REQUEST- May 3, 2019

(ST1909) Glen Eagle PUD minor revision. David Woods is requesting minor revisions to the approved preliminary and final development plan for the number and design of units, as follows:

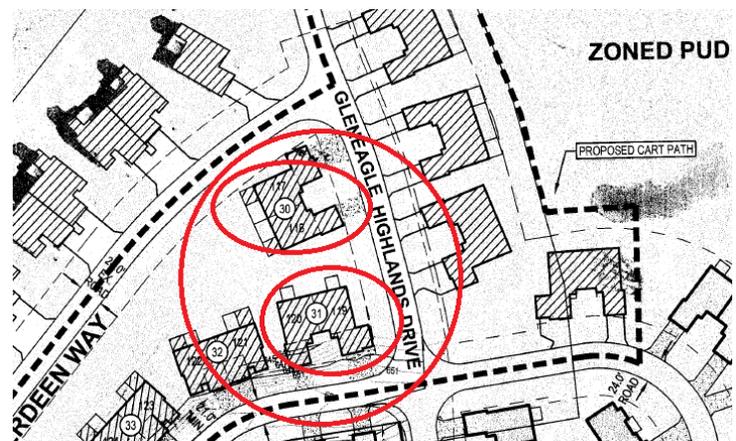
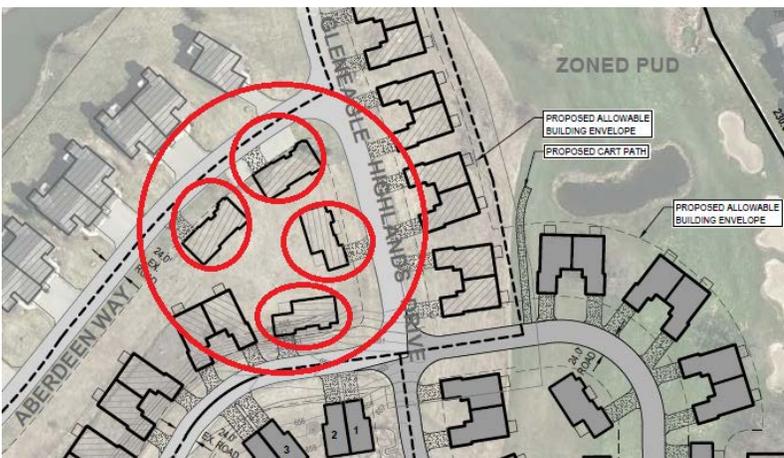
1. Two previous revisions were made and no formal application was submitted because it was a change within the building envelope with a reduction in the number of units. These were allowed as per the minutes) for:
 - a. Five units east of Gleneagle Highland Dr. were reduced to four. (**Reduction of one unit**)

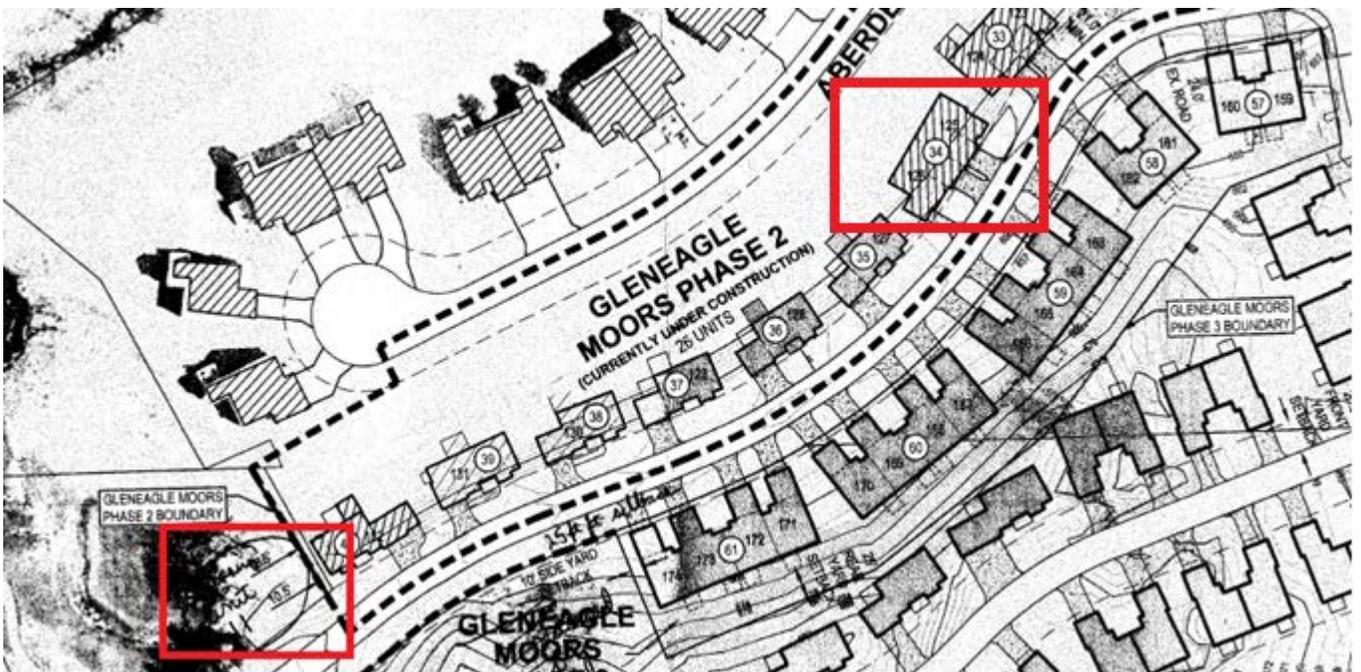
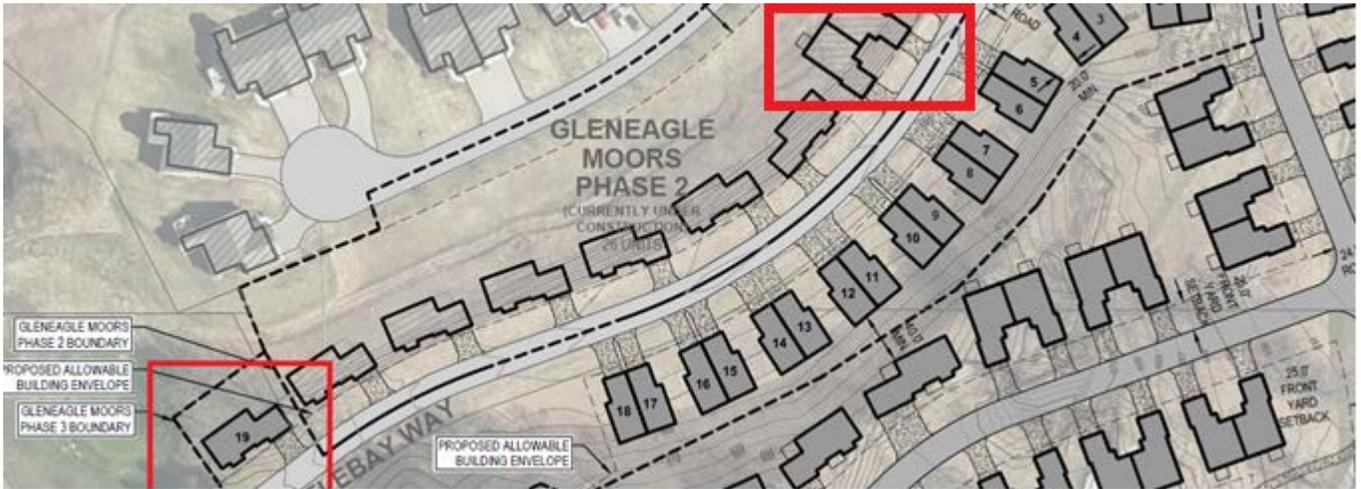
- b. Four single units west of Gleneagle Highland Dr. were changed to two duplex units. (**No reduction in the number of units**)

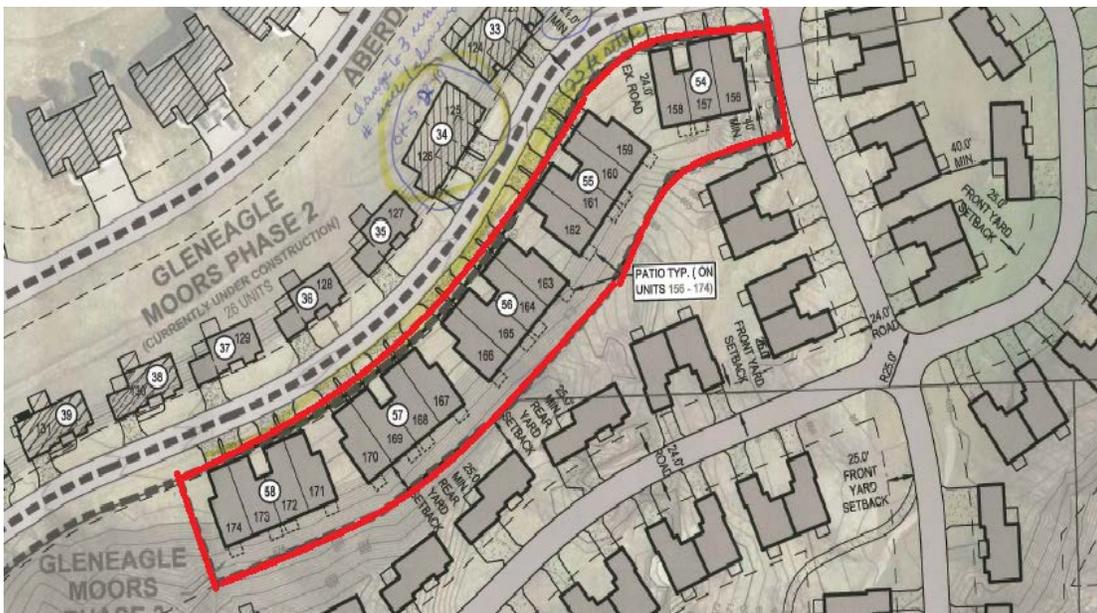
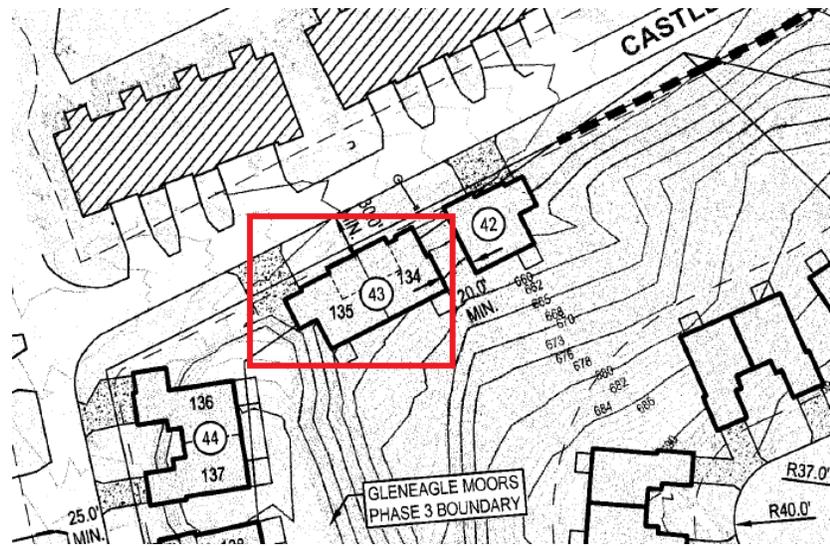
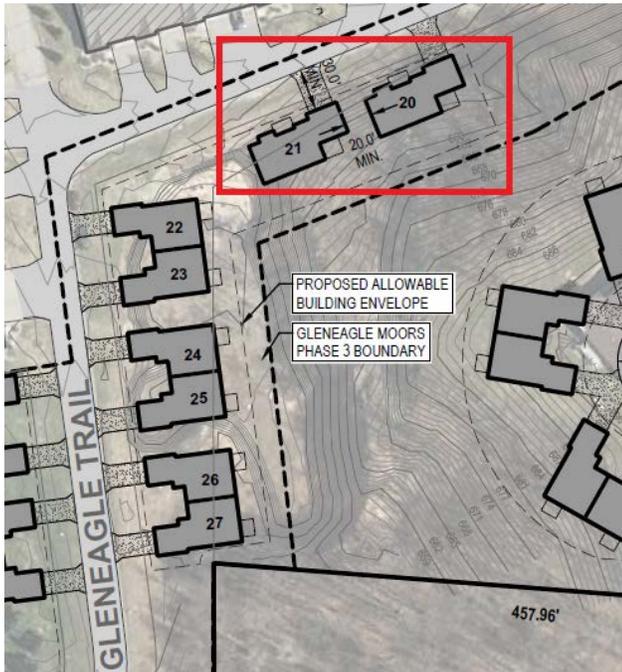
3. The previously approved nine duplex buildings (total of 18 units) on the south side of Castlebay Way (shown below from the previously approved preliminary plan) are proposed to be redesigned, along with an increase of one unit, to one tri-plex buildings (3 units), plus 4 four-plexes (16 units) for a total of 19 units (shown on the second map). This results in an overall net increase of one unit. Consequently, to keep the total of units from exceeding the number approved with the preliminary plan, there will be a reduction of one unit in the future phase 4, Gleneagle Highlands. Also note that these 19 units in the five buildings have a minimum front yard setback of 25 feet. The buildings across Castlebay Way were the **ONLY** units approved to have a 21 foot front yard setback.

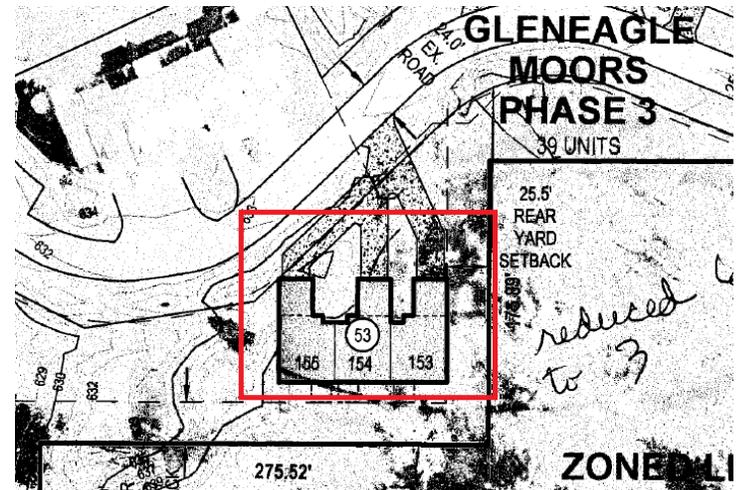
4. A change from two single stand-alone buildings to one single stand-alone and one duplex unit. (Addition of one unit)
